# **Power Backoff Consideration in Clause 55.7.3.3 May Lead to Wrong Result on AxTalk**

**Agilent Technologies**

**Feb 2006**

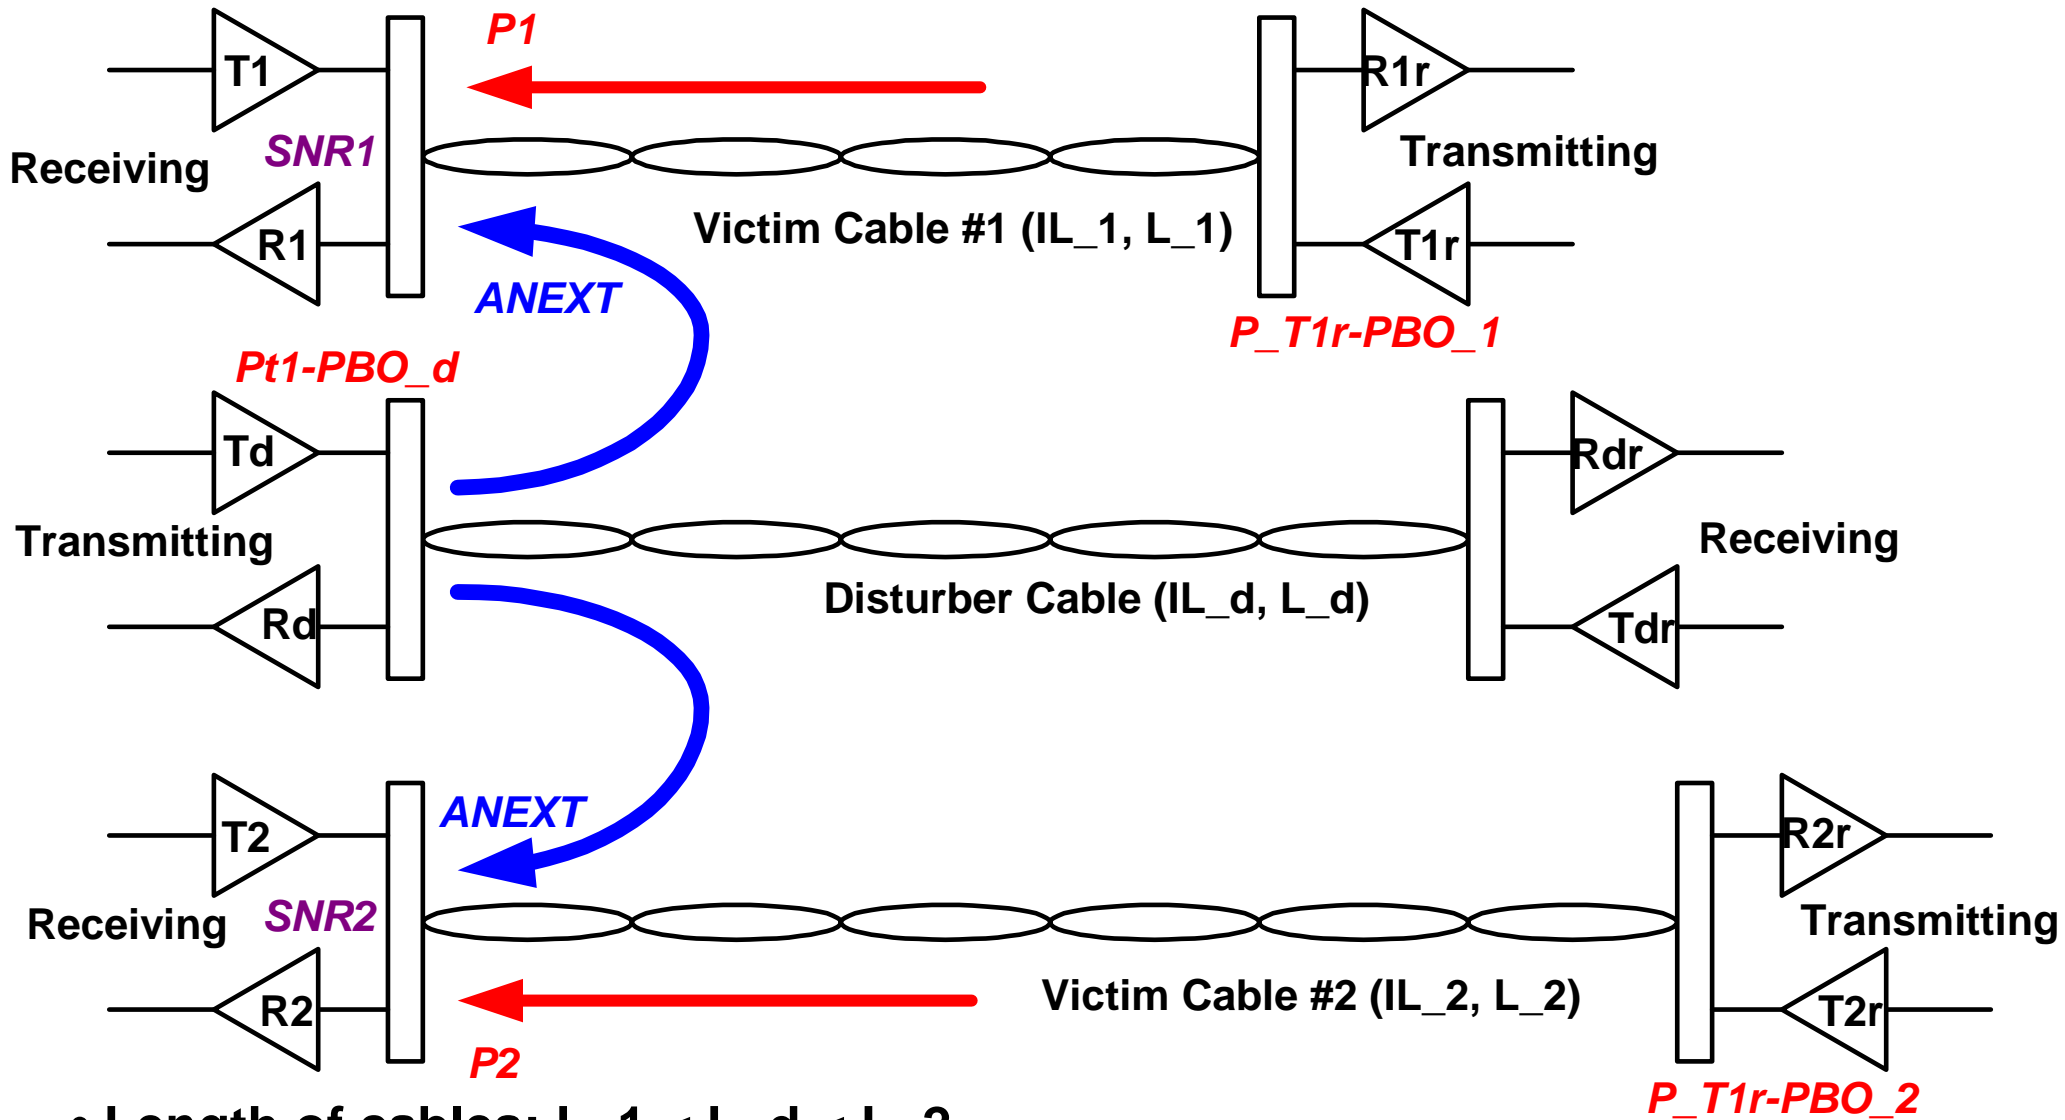
- Length of cables:  $L_1 < L_d < L_2$
- Insertion loss of cables:  $IL_1 < IL_d < IL_2$
- Received Power at near end:  $P1, P2$  (=  $T_{xr\_power} - back\_off - insertion\ loss$ )

Conclusion: power back-off considerations will cause different measurement results for the channels experiencing same noise and having same received power

**The power backoff compensation proposed in Clause 55.7.3 may lead to difference between the actual and computed PSANEXT.**
